SP2026-005: Site Plan for 5013 Coffee

## PLANNING AND ZONING COMMISSION CASE MEMO

**CASE NUMBER:** SP2026-005; *Site Plan for a Restaurant with Less Than 2,000 SF with Drive-Through or Drive-In (5013 Coffee)*

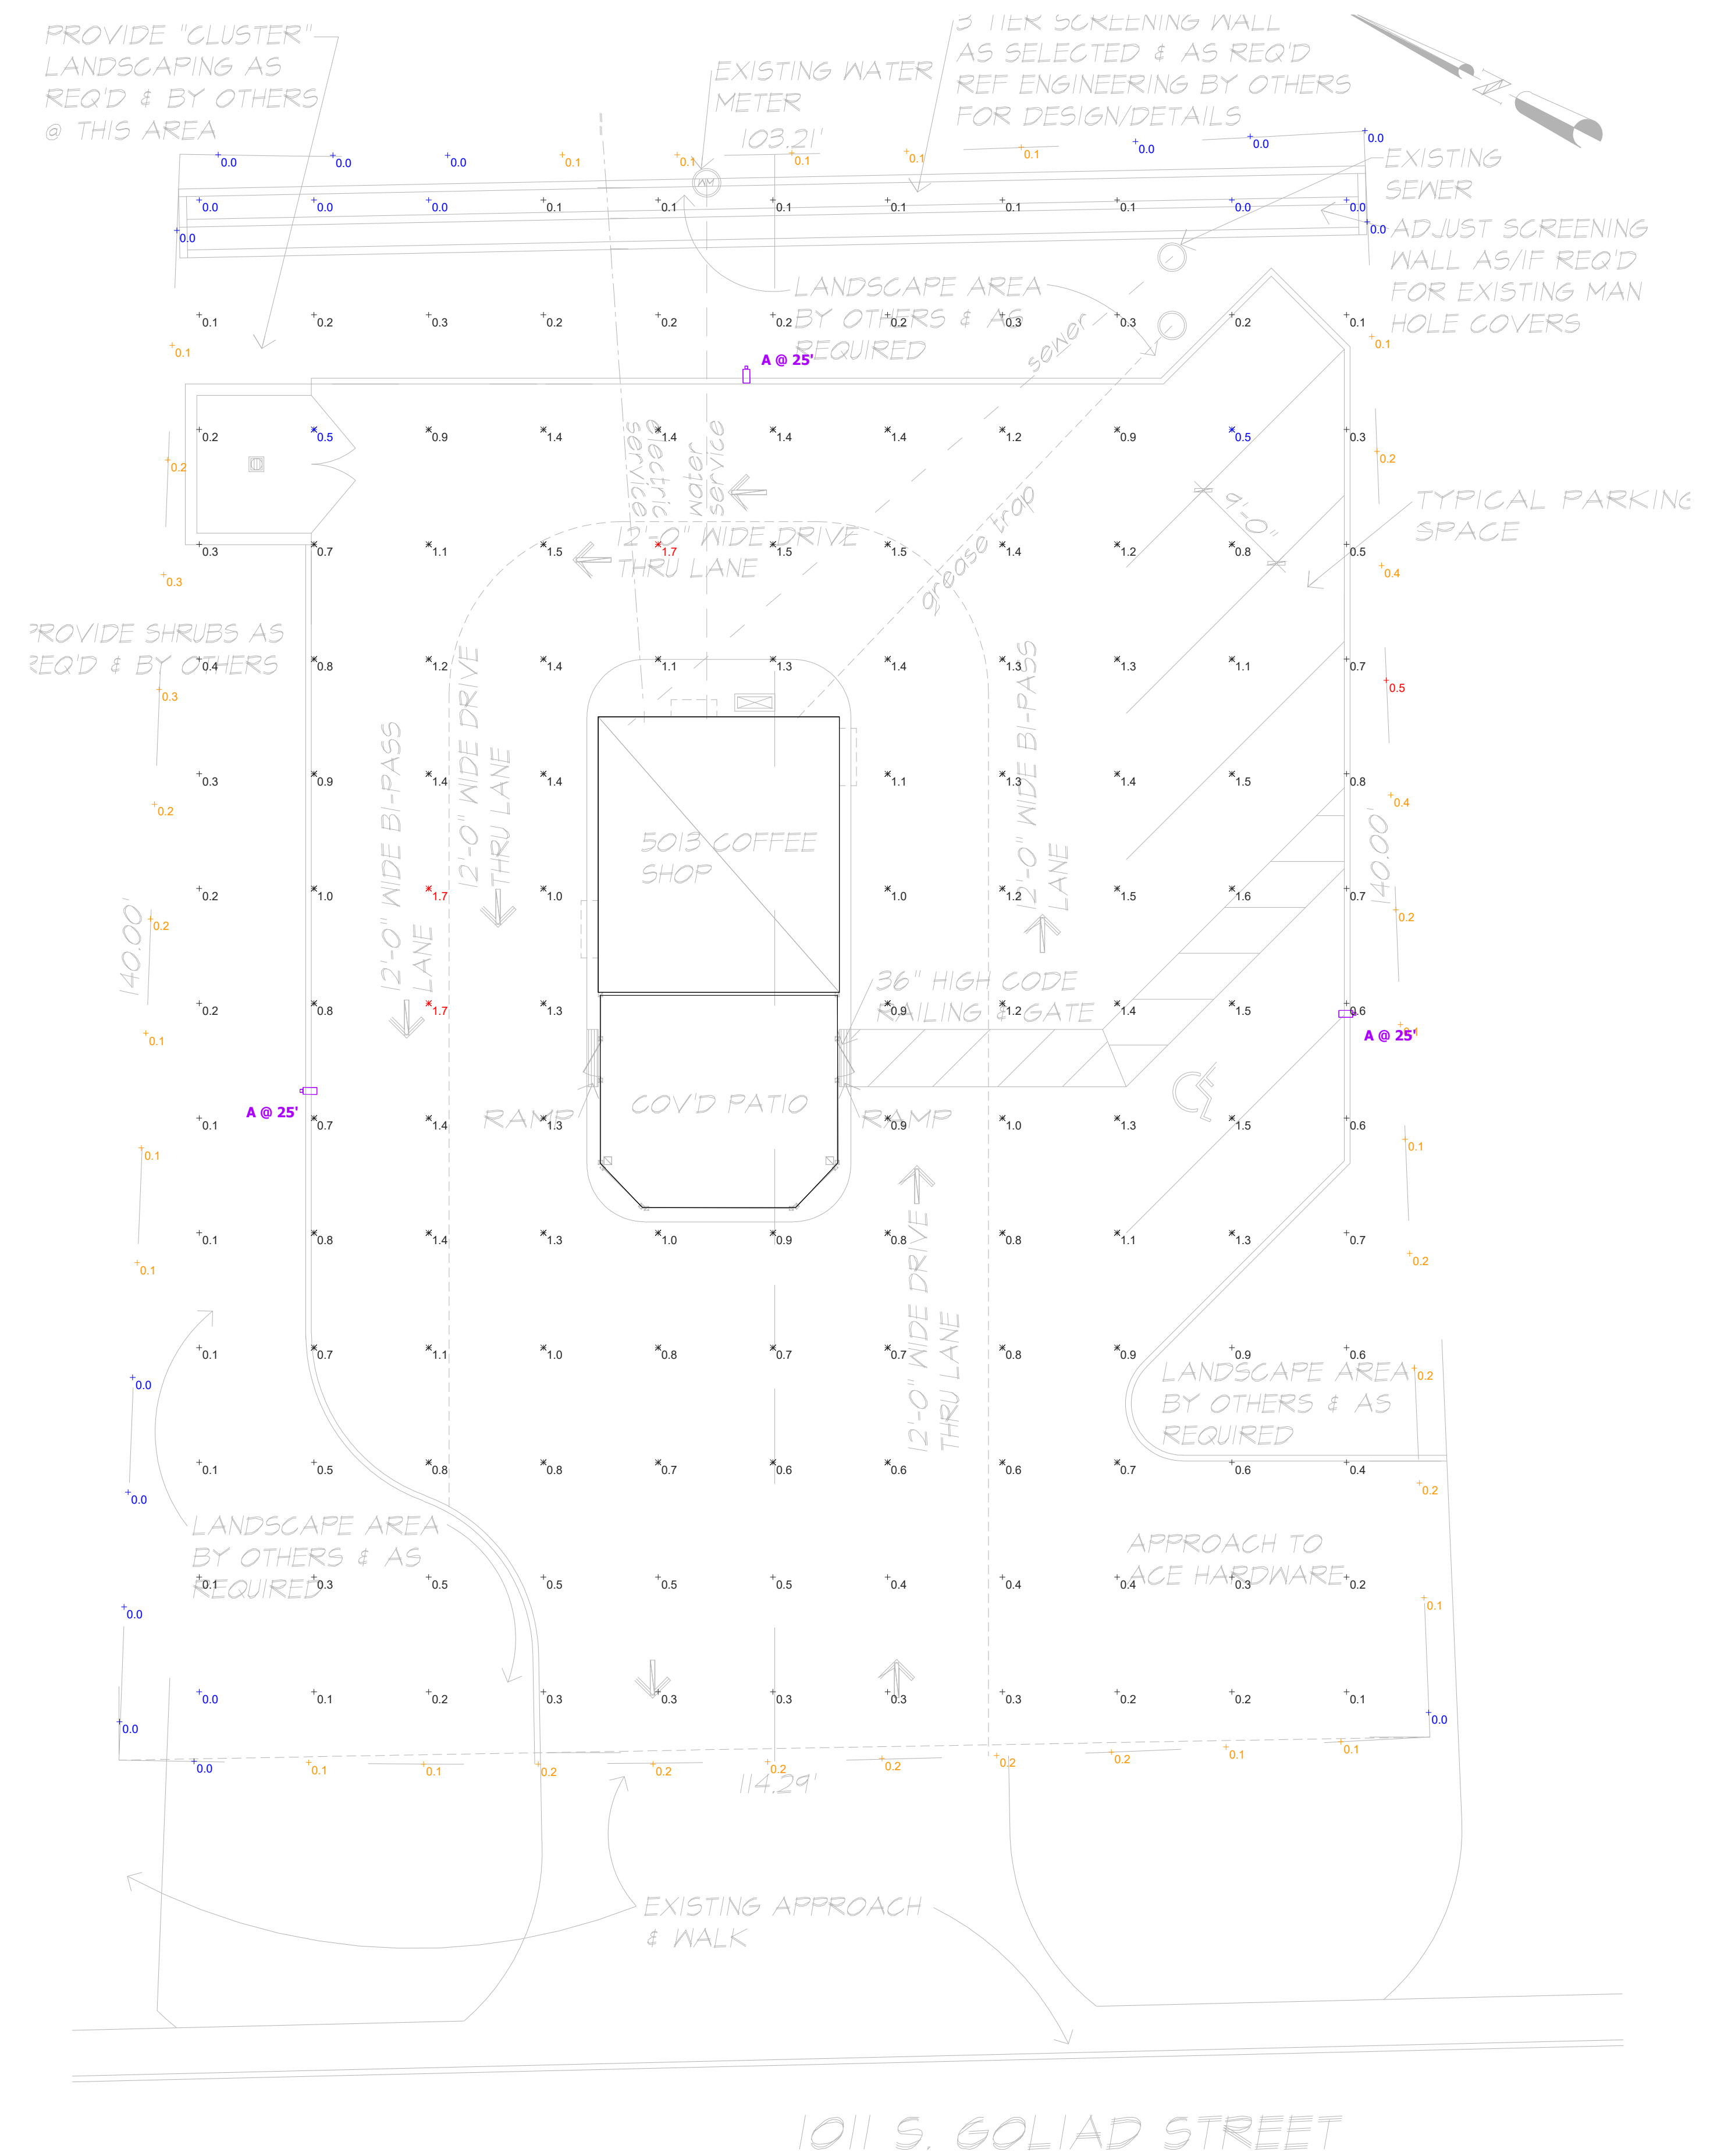
- (4) Three (3) tiered screening (i.e. one [1] row of canopy trees, one [1] row of accent trees and large shrubs, and one [1] row of lower level shrubs) shall be required adjacent to the eastern property line (adjacent to the existing residentially zoned or used properties). A new Landscape Plan showing conformance to the requirements of the UDC will be required prior to the acceptance of civil engineering plans. Please refer to Appendix C, Landscaping Guidelines and Requirements, of the UDC for the approved tree species as the proposed Crape Myrtles shown on the Landscape Plan are not allowed.

Plan View

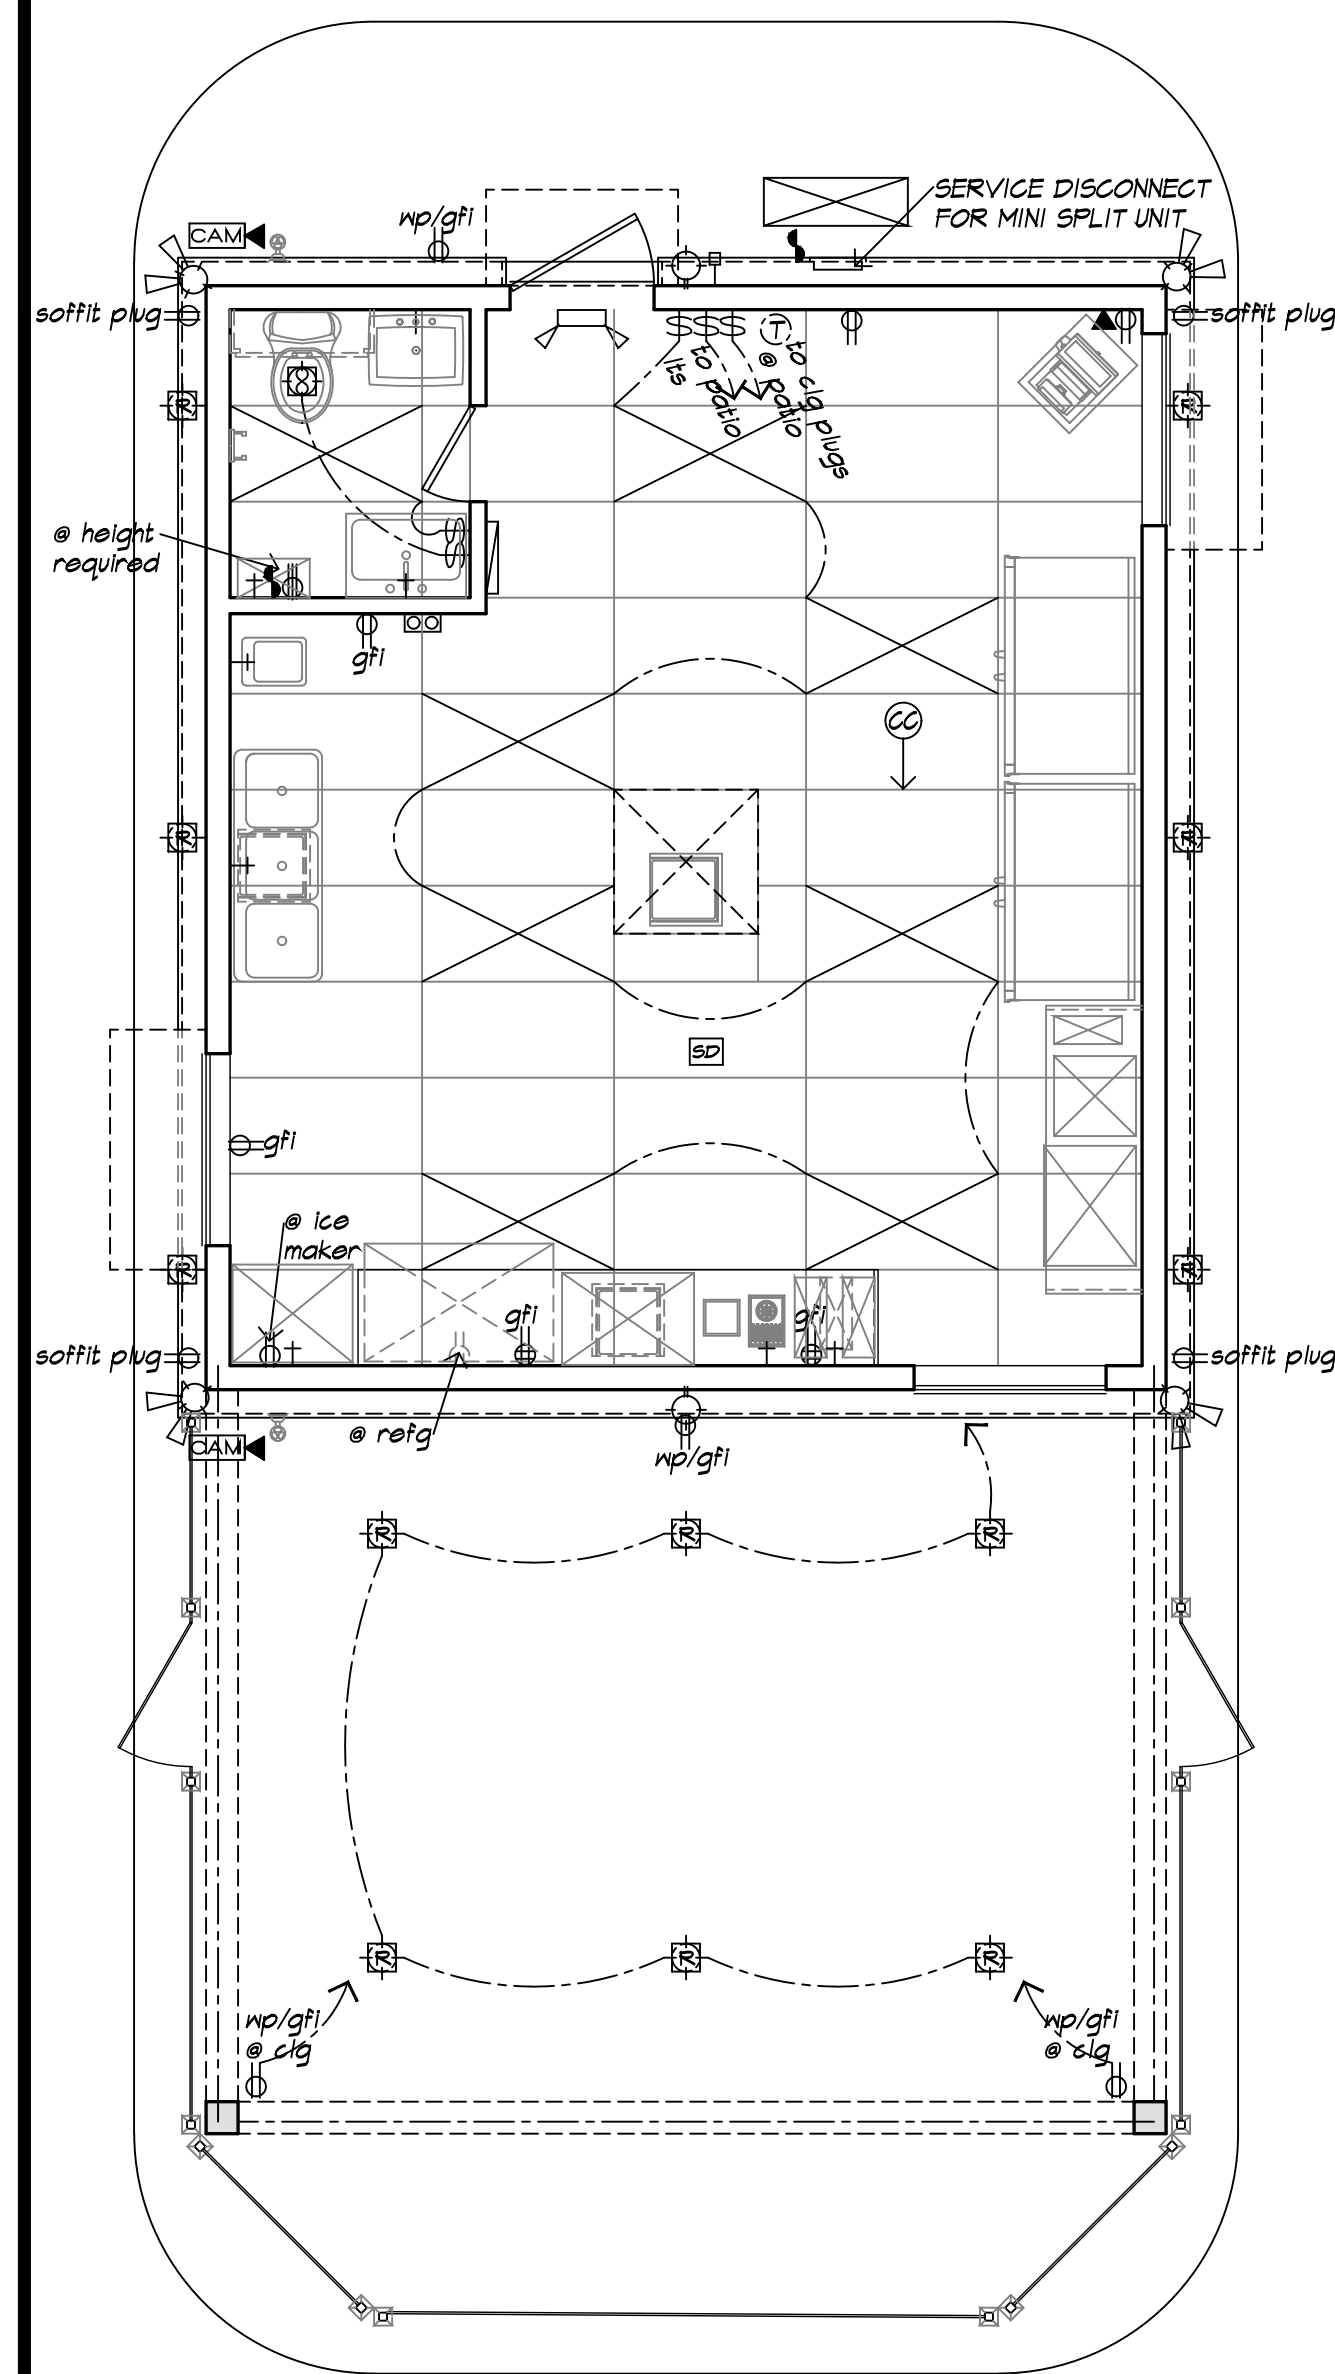
- (3) Lighting Standards. According to Subsection 06.02, *General Overlay District Standards*, of Article 05, *District Development Standards*, of the Unified Development Code (UDC), no light standard, light fixture, light pole, pole base or combination thereof shall exceed 20-feet in total height in any overlay district. In this case, the applicant's photometric plan indicates that some pole heights are 25-feet in height. This will require a variance from the Planning and Zoning Commission.

- (4) Light at Non-Residential Property Line. According to Subsection 03.03, *Minimum Requirements*, of Article 07, *Environmental Performance*, of the Unified Development Code (UDC), the foot-candles at all property lines must not exceed 0.2 FC. In this case, there are areas along the northern and southern property lines where the light levels exceed 0.2 FC. This will require an exception from the Planning and Zoning Commission.
